Revisions
Bubbled areas indicate revisions compared to the previously submitted plans.
Received Date
June 16, 2022

project name
Capital Culture District
1824, 1900, 1907, 1908, 1924, 2010 Store Street and 530 Chatham Street
sheet title
Site Sections

project no.	1931
drawing file	Comprehensive Plan
scale	As Noted
drawn by	JB/JH
date issued	June 3, 2022
sheet no.	A3.1

Tree Survey

Tree Management Plan

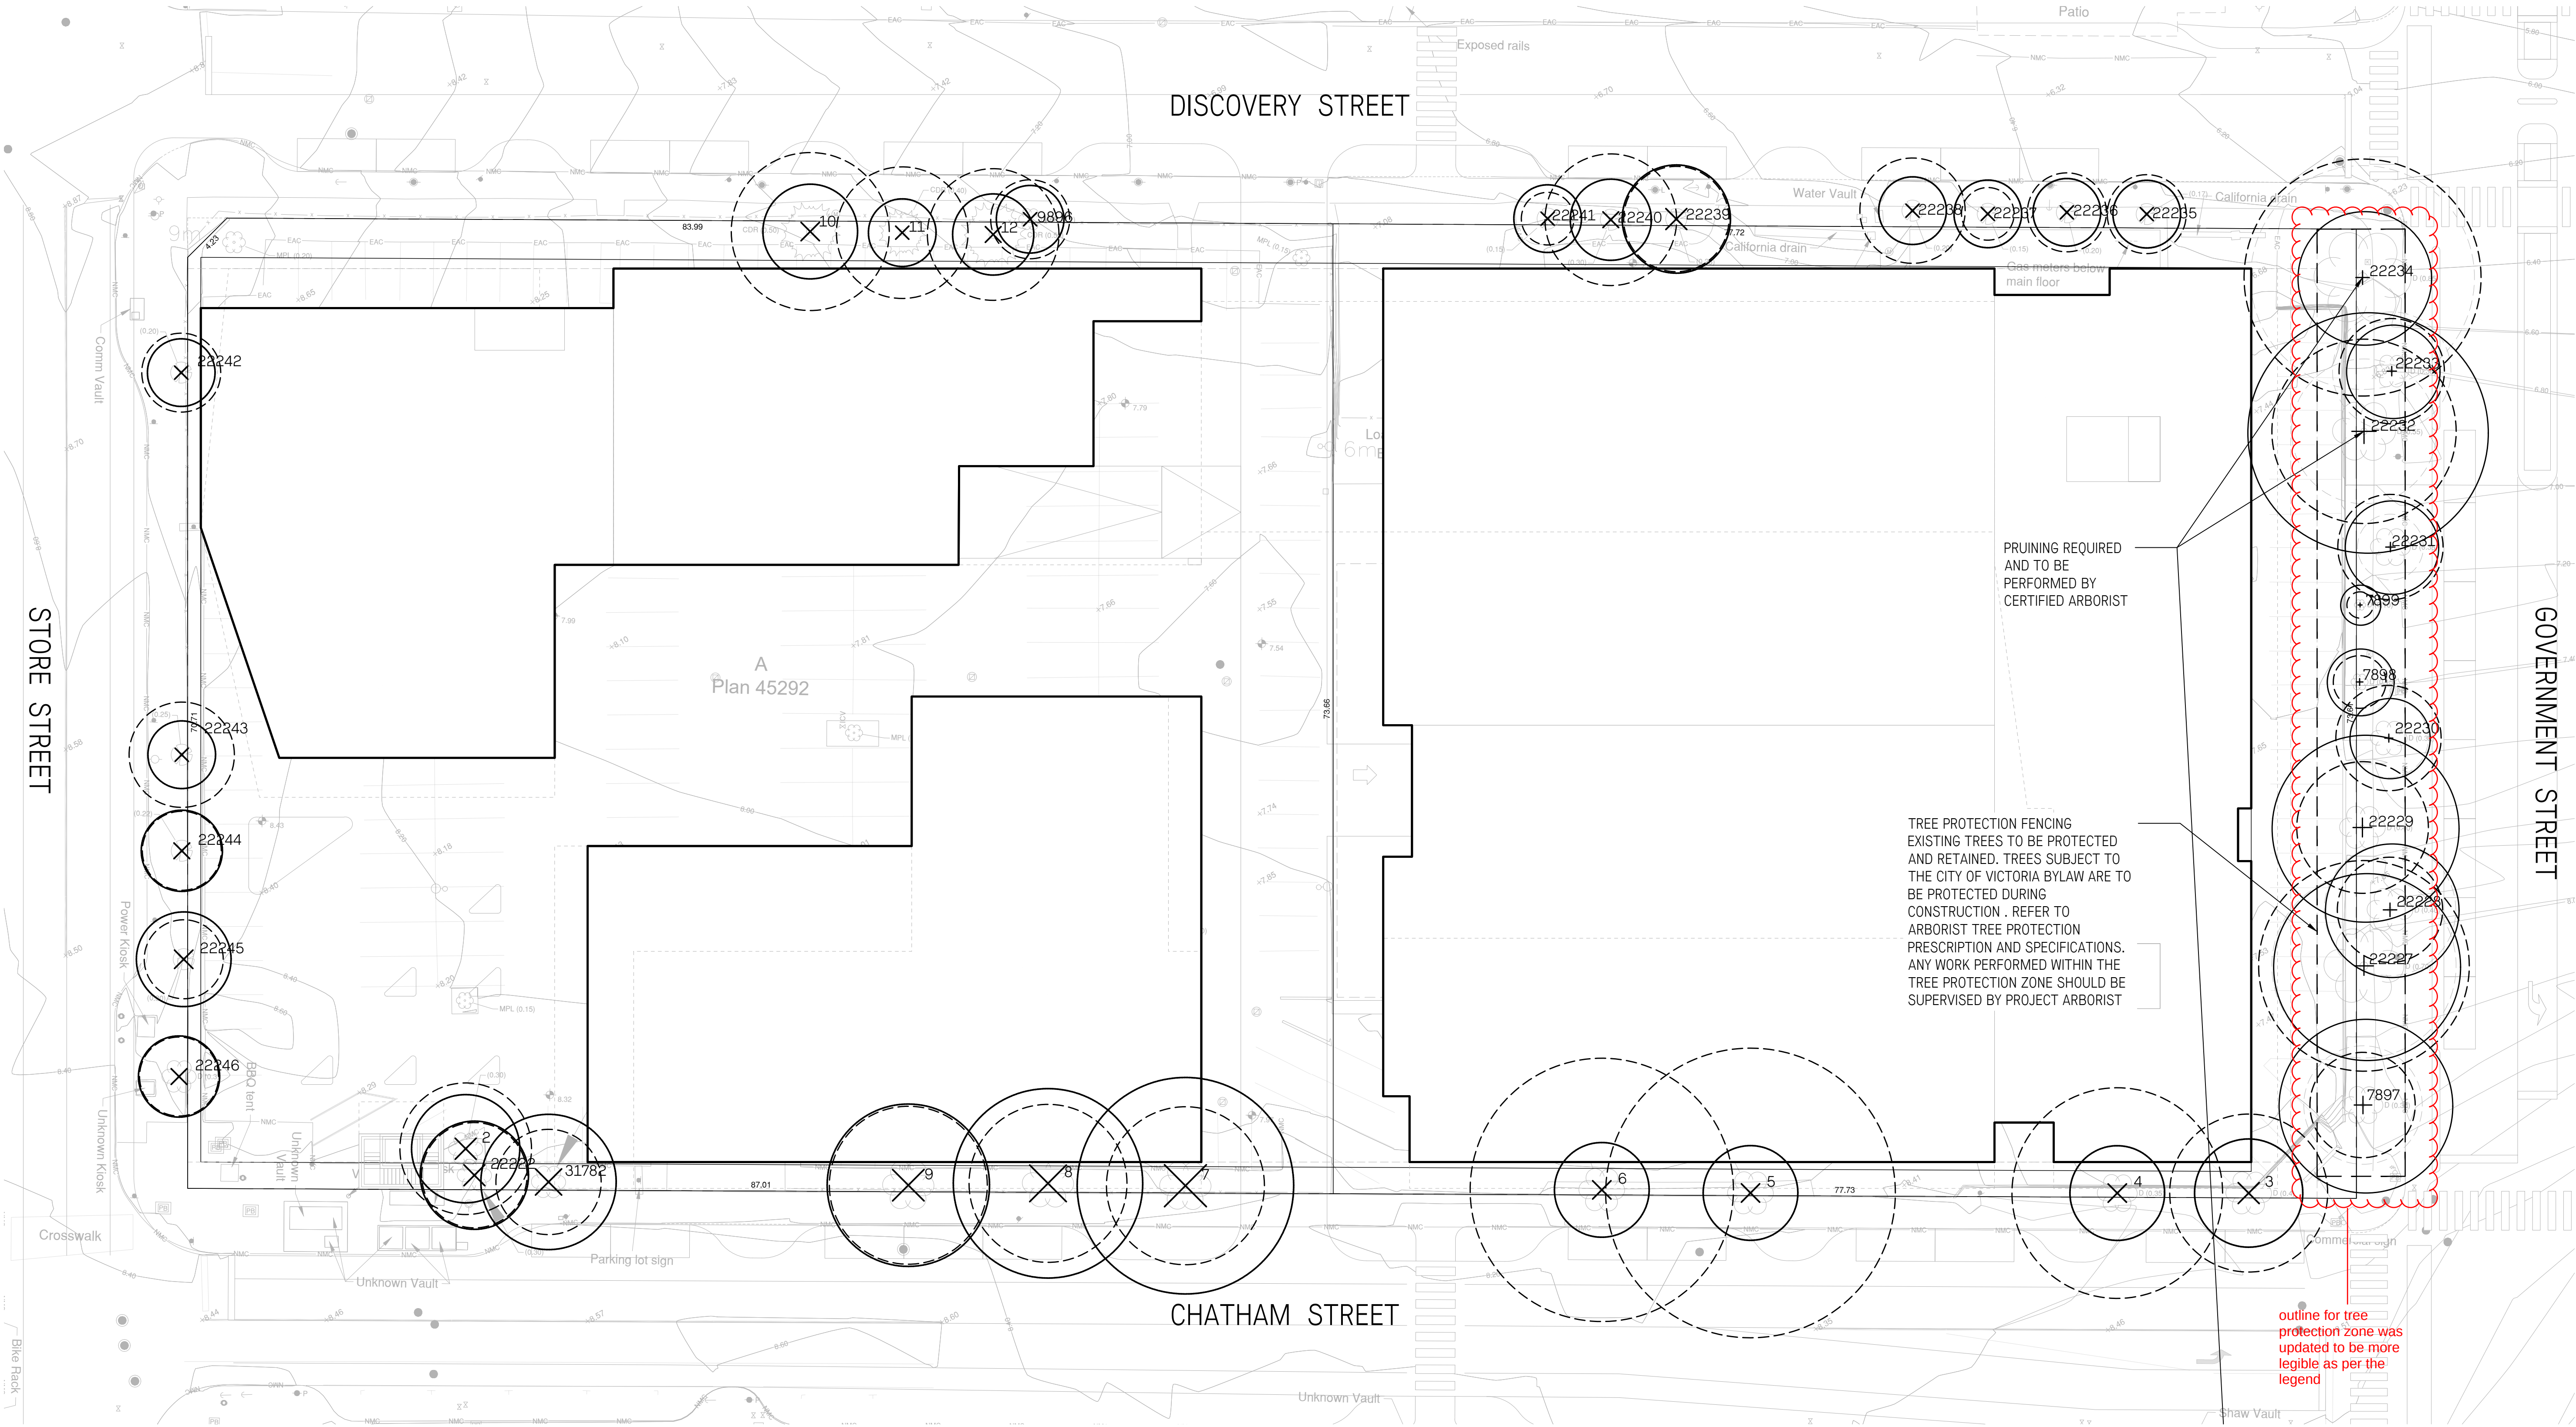
The legend was added here for clarity and the note below.
